Doc. Type: Disposition of comments

Title: Disposition of comments on ISO/IEC CD 10646 5th edition

Source: Michel Suignard (project editor)

Date: 2019-02-07

TE.6. Page 2768, A.5.10 390 MOJI-JOHO-KIBAN IDEOGRAPHS-2016 and A.5.11 391 MOJI-JOHO-KIBAN IDEOGRAPHS-2018

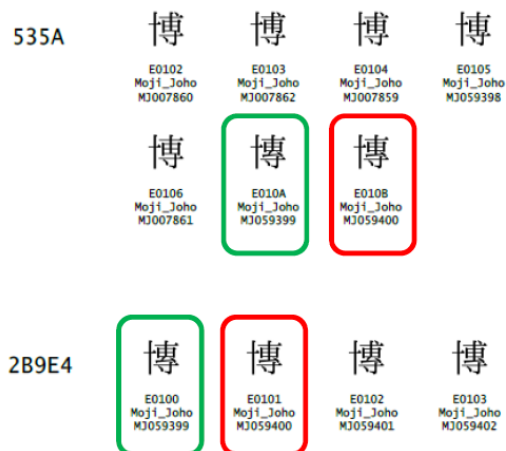
In IVD registration of Moji_Joho collection ([Registration of additional sequences in the Moji_Joho collection, dated 2017-12-12](#)), it is found that two different IVSs are registered for one glyph redundantly. As shown in the following figure, [535A E010A] and [2B9E4 E0100] are registered for Moji_Joho MJ059399, also [535A E010B] and [2B9E4 E0101] are registered for Moji_Joho MJ059400.

- In JMJKI-2018.txt, delete <535A E010A> and <535A E010B> in the line starting from "535A."
- Associating with this change, add the following statement in Page 2768, Annex A.5.10 390 MOJI-JOHO-KIBAN IDEOGRAPHS-2016 as NOTE, such as "<535A,E010A> and <535A,E010B> have been removed in collection 391."
